TECHNICAL BULLETIN

• TB-009 • Oct 2008 •

No-Slack® Top Plate Installation

This Technical Bulletin supercedes Technical Bulletins TB-001 and TB-009 dated Nov. 2000. It covers the replacement of your Fontaine® fifth wheel with the current No-Slack® 6000, 7000 or 7000CC top plate (both the standard and air actuated).

Figure 1

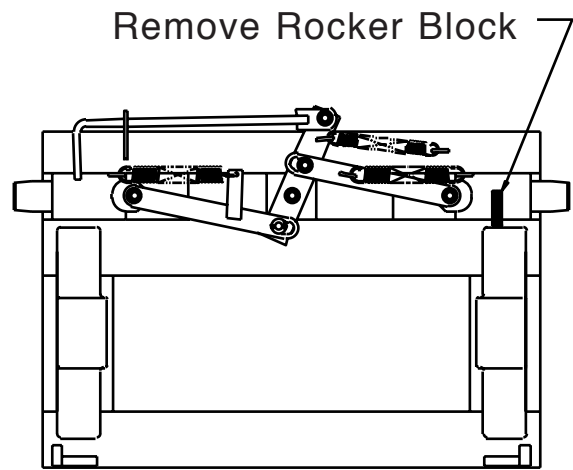
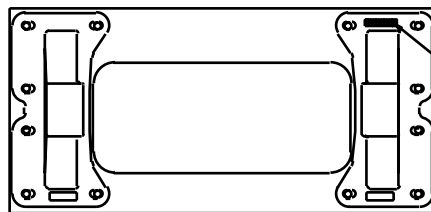
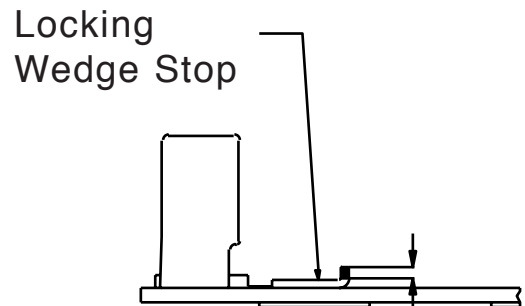
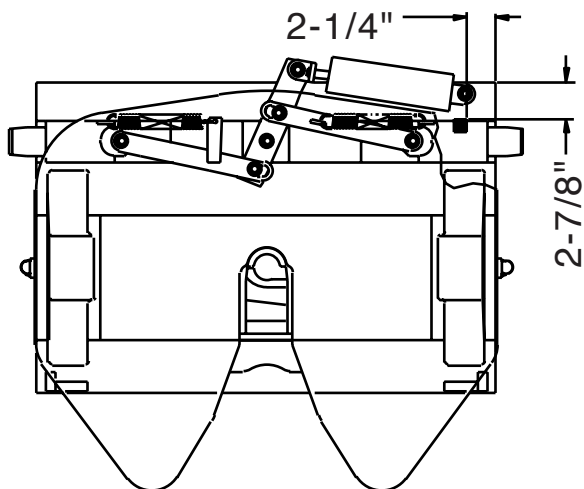
1. Find your bracket style requiring modification in Figure 1 and remove the existing rocker block as shown.
2. Determine the height of the new rocker block required for your mounting style and height from Table 1.

Trim 1/2" off vertical leg

Figure 2

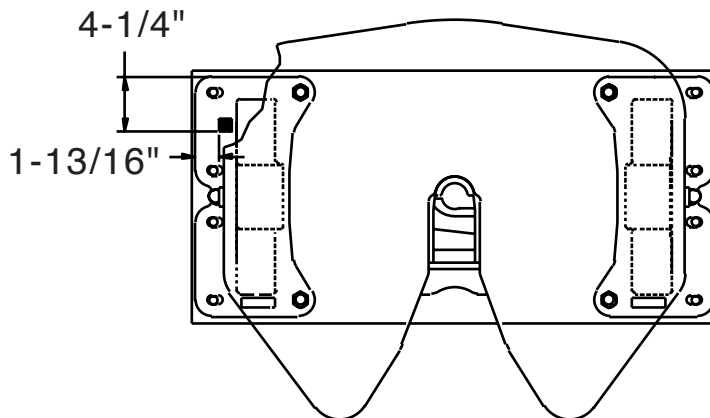
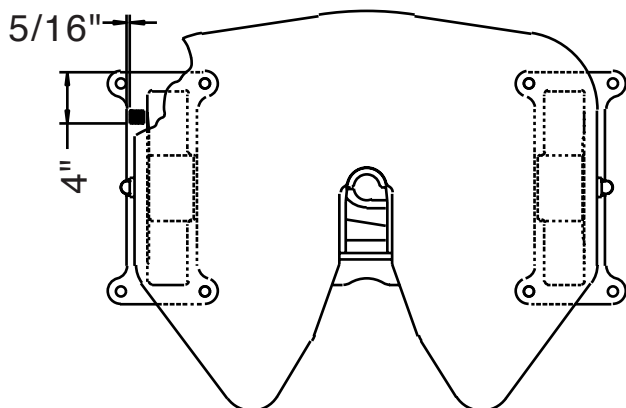
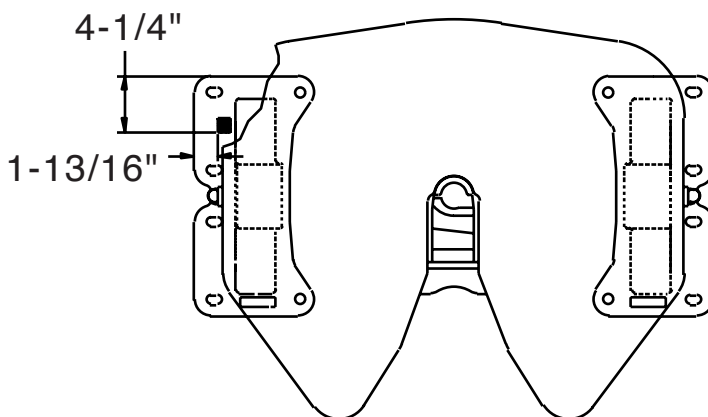
4. With your Fontaine No-Slack® fifth wheel installed, locate the new rocker block as shown on the appropriate bracket model configuration in Figure 2. Tack weld the block and tilt the fifth wheel forward to make sure it contacts the new rocker block and clears all parts of the locking system. Check to make sure there is no interference with the air cylinder (on air operated fifth wheel models) or the slider's latching mechanism (if being mounted on a slide). Complete welding the rocker block in place.

* The No-Slack® 6000, 7000 or 7000CC
cannot be used on AWS 6-3/4"
mounting heights.
